MANUAL CHANGES

Model Number: 8690B-H26
Date Printed: March 1969
Date Number: 00000 0100

Part Number: 08690-91004

Figure 1. Model H26-8690B Rear View (Part of Change 1)

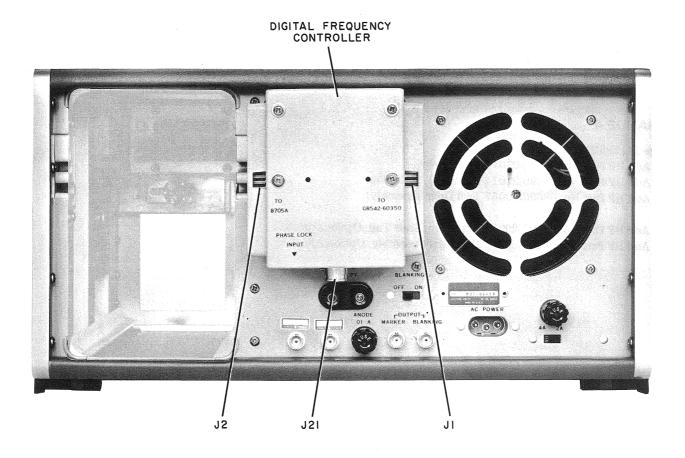
Replace figure in manual with attached Figure 1.

Add a BNC connector to the left of the SWEEP connector. Label the new connector TUN VOLTAGE. The connector transmits the tuning voltage to the 85405A Control Unit in the 8543A Automatic Network Analyzer.
